M4-M5 SSI-7485-Mod-2 ROZELLE INTERCHANGE COMMUNITY COMMENT

We would like to see better urban outcomes for its 100 year lifespan

MOD 2 scheme has not adequately reviewed landscape opportunities

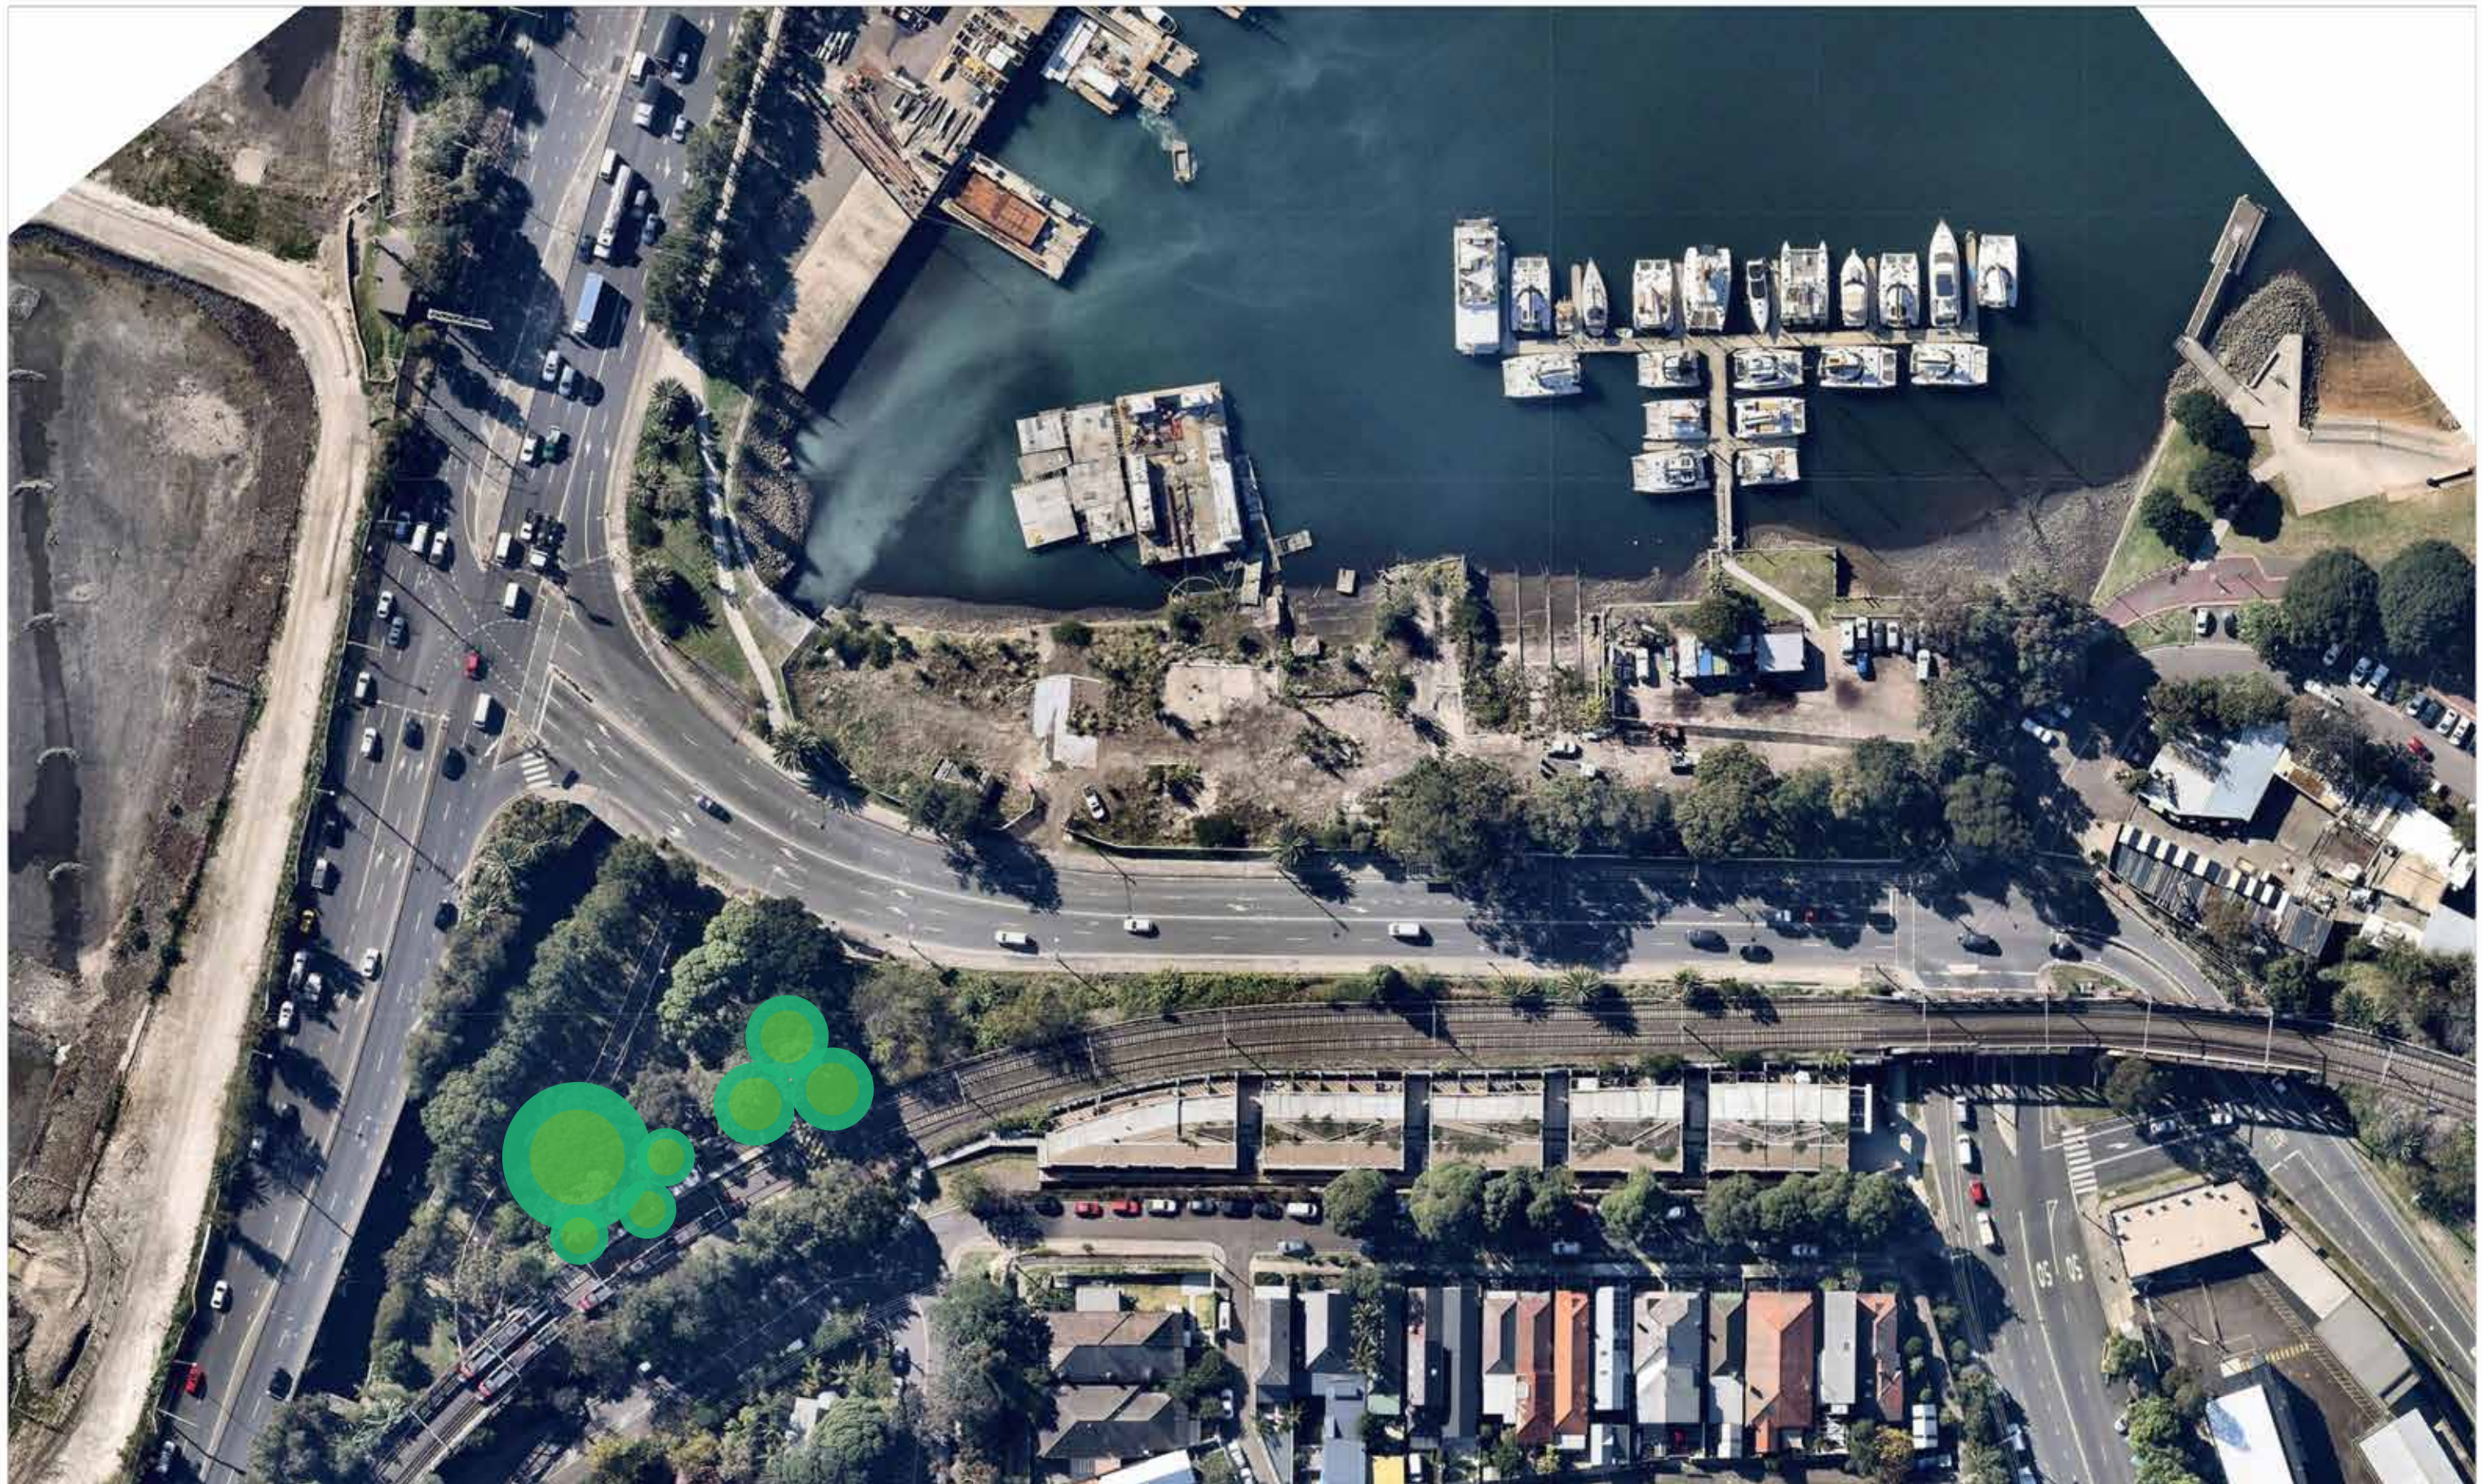
Significant embankment trees and fig that could be retained

Road alignment and line marking adjustments to retain trees

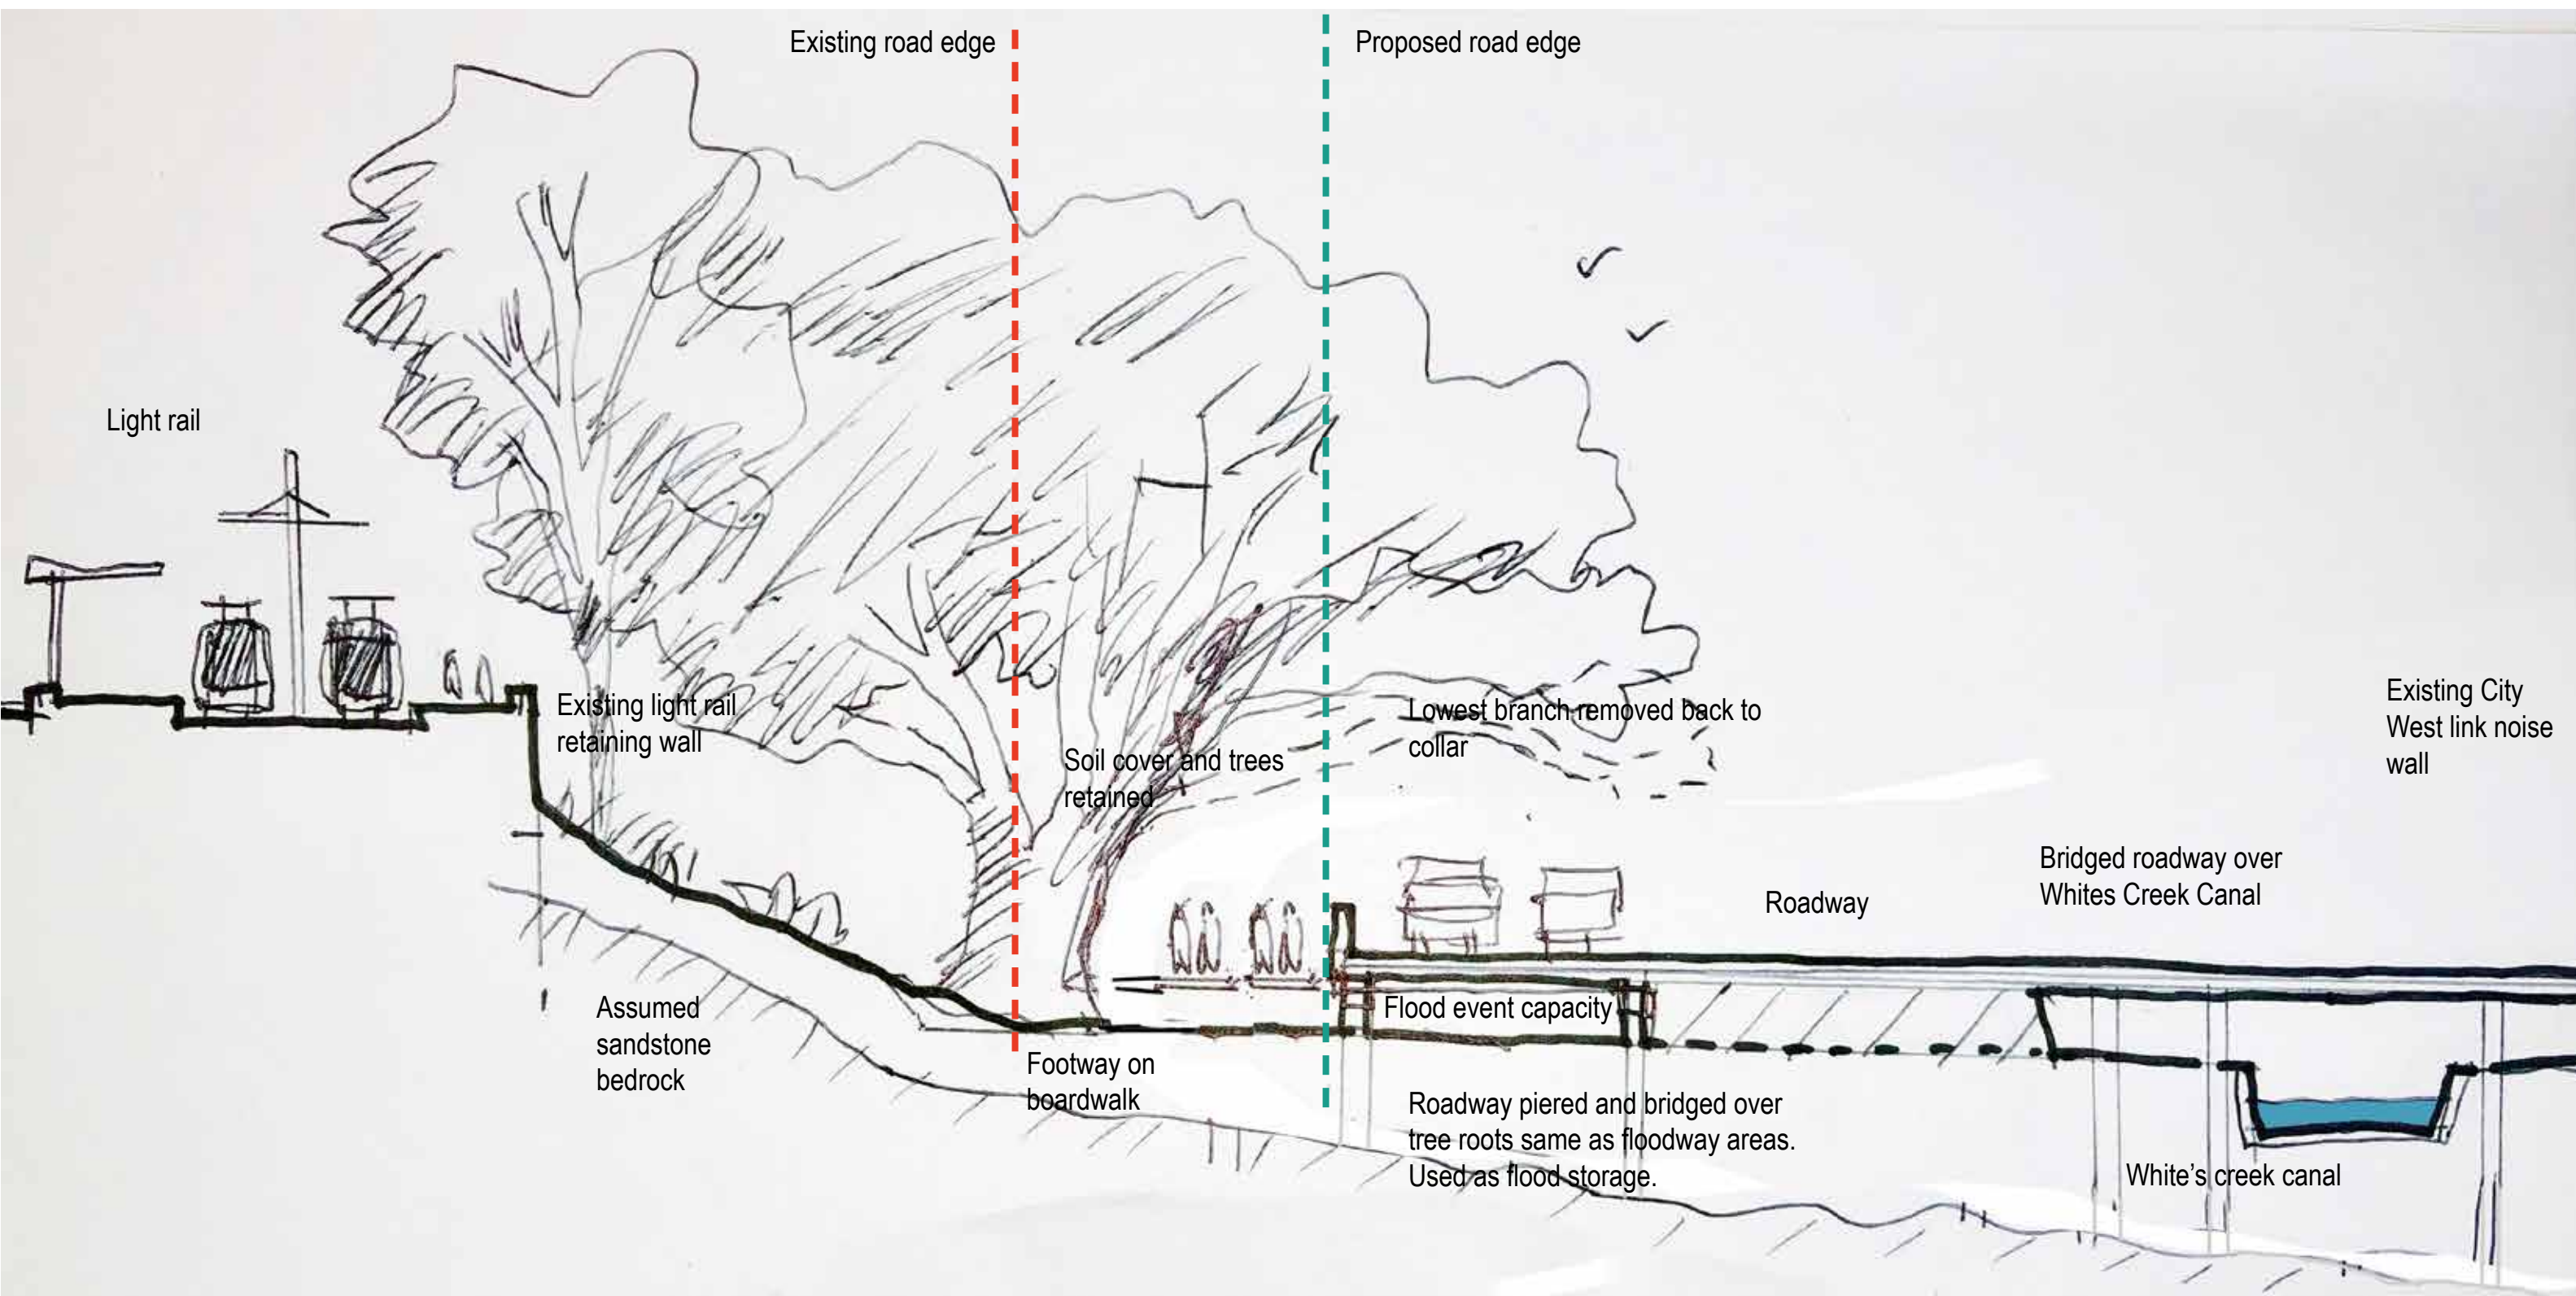
Light rail embankment trees – 15m tall Sydney Blue Gums

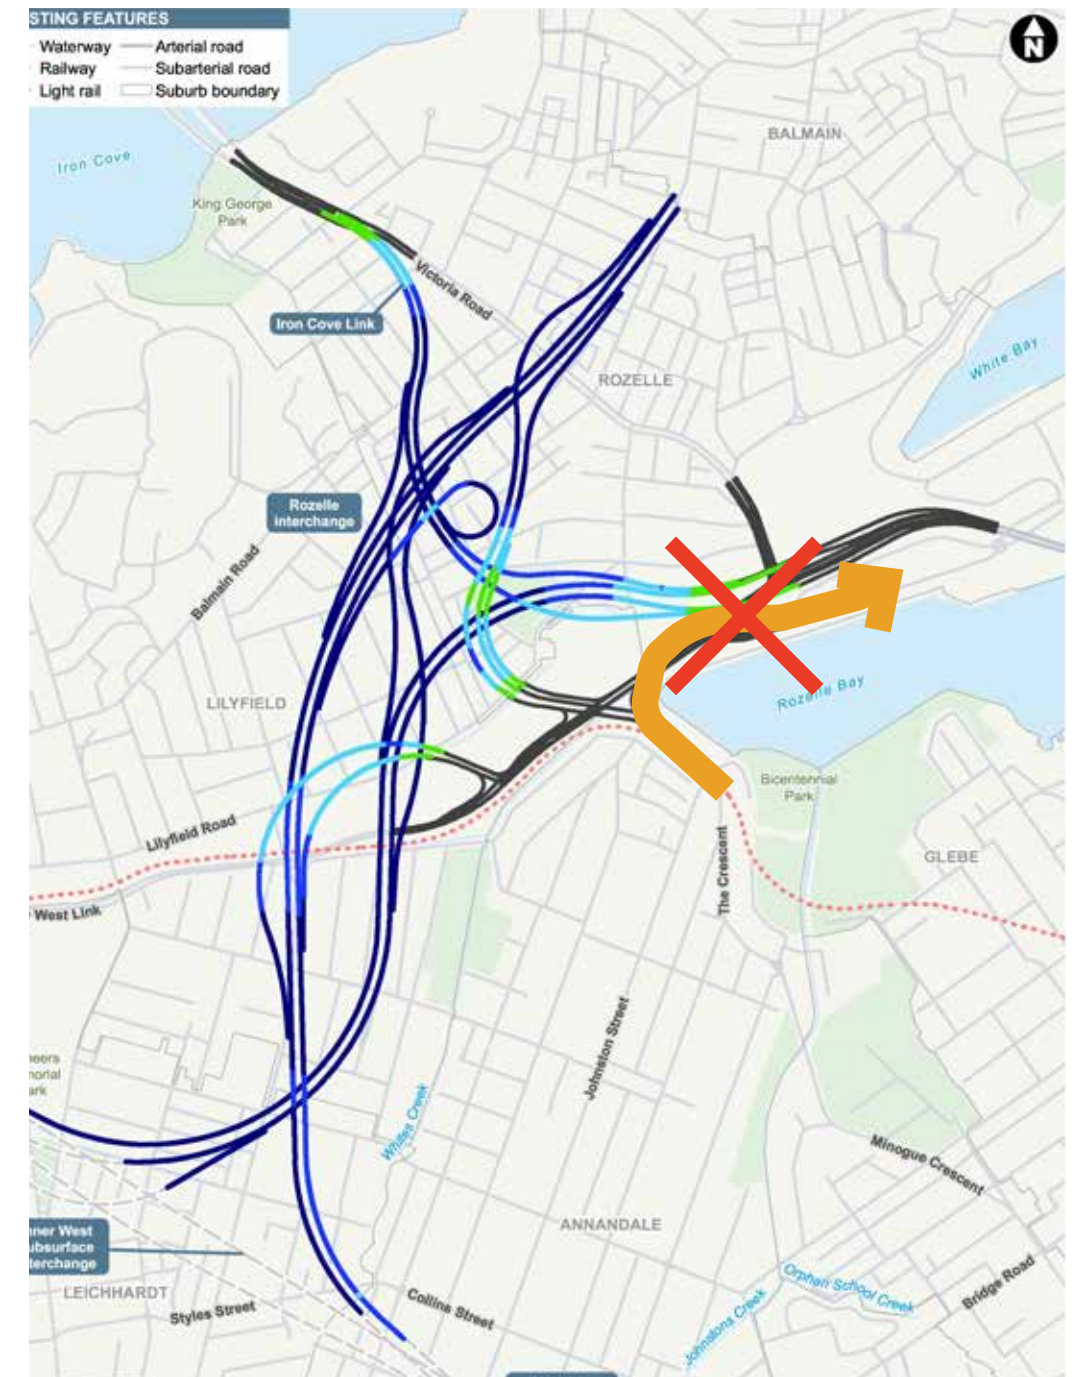
Now no right turn from Johnston Street to the Tram sheds, Glebe, Sydney University and other destinations.

Now no right turn from The Crescent into James Craig Drive and possible future residential communities.

Only option 1 maintained this

This should be reinstated
